Access Compliance Report

Public Rights-of-Way

Intersection ID: 30297	Main Street: BLACK_KETTLE_DR	Cross Street: MAGLEV_LN	Location:	N
ADA ID: D86A1D524AA6	Ramp Type: PerpDiag	Initial Pass/Fail: Pass	Overall Compliance: No	Severity Score: 22.75
Codes/Mitigation Info/Possible Solution		Field Measurements/Component Compliance

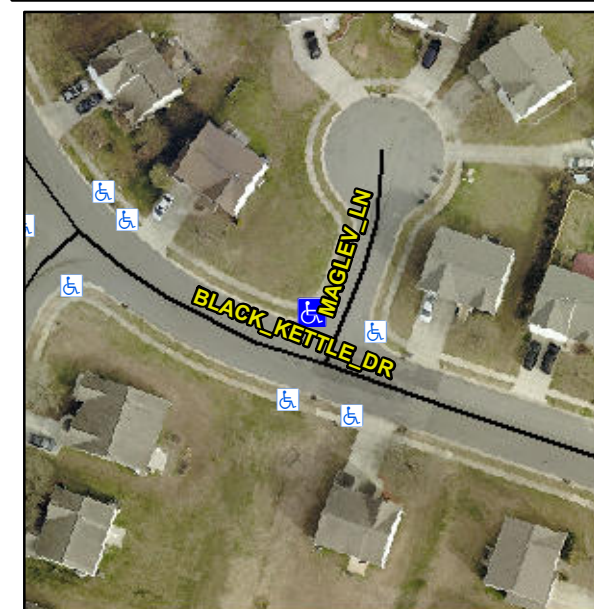
Compliance	Description	Data	Compliance	Description	Data
N/A	Ramp Length (in)	49.0	Yes	Ramp Slope (%)	5.3
Yes	Ramp Width (in)	59.0	No	Ramp XSlope (%)	4.0
N/A	Flare Type LT	Sloped	N/A	Flare Type RT	N/A
N/A	Flare Slope LT (%)	2.2	N/A	Flare Slope RT (%)	5.7
N/A	Flare Traversable LT?	No	N/A	Flare Traversable RT?	No
No	Landing Length (in)	47.0	No	DWS Provided?	No
Yes	Landing Width (in)	65.5	N/A	DWS Contrast?	No
No	Landing Slope (%)	3.7	N/A	DWS Length (in)	N/A
No	Landing X Slope (%)	3.0	N/A	DWS Full Width?	No
N/A	Landing Curb? (Y/N)	No	N/A	DWS Offset (in)	N/A
N/A	Shared Landing?	No			
Yes	Gutter Ponding?	No	No	Gutter Slope (%)	8.4
No	Gutter Lip Ht (in)	0.5	No	Gutter X Slope (%)	4.8
N/A	Painted X Walk1?	No	N/A	Painted X Walk2?	No
	X Walk 1 Direction	To SW		X Walk 2 Direction	To SE
N/A	X Walk 1 Width (in)	N/A	N/A	X Walk 2 Width (in)	N/A
	X Walk 1 Slope (%)	1.8		X Walk 2 Slope (%)	6.0
	X Walk 1 X Slope (%)	6.3		X Walk 2 X Slope (%)	2.2

N/A	Ramp inside XWalk1?	N/A	N/A	Ramp inside XWalk2?	N/A
	Road Slope (%)	4.7	N/A	Clear Space?	Yes
	Road X Slope (%)	7.2	N/A	Clear Space to XWalk (in)	N/A
Yes	Any Obstructions?	No	Yes	Storm Grate/Utility Hazard?	No
	Obstruction Type			Storm Grate/Utility Type	
		N/A			N/A
			Yes	Surface Condition? (G/P)	Good

Remove & Replace Curb Ramp With Two New Directional Ramps or Equivalent. Remove & Replace Gutter.
